New bolt - tensioning pulley 531 0278 30

Manufacturer:
Volkswagen

Model: Transporter T4

Engine: 2.5 Petrol

Fig. 3: LuK AS bolt

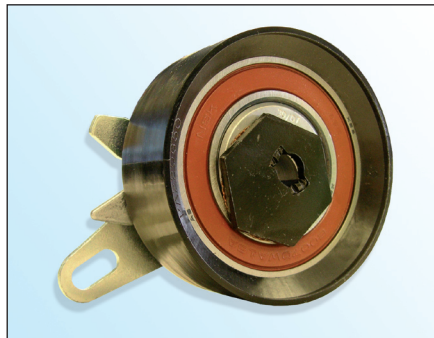
As part of the continuous development of our products and quality assurance, LuK AS now supplies a new bolt (**fig. 3**) with the tensioning pulley **531 0278 30**.

Features:

- flat bolt head with Torx
- Bolt head \varnothing 18.5 mm
- Bolt grade 10.9
- Thread locking medium on the bolt
- Increased self-locking

LuK AS recommends replacing the original bolt (**Fig. 2**) with the supplied bolt.

Tightening torque: $20 \pm 1,5$ Nm
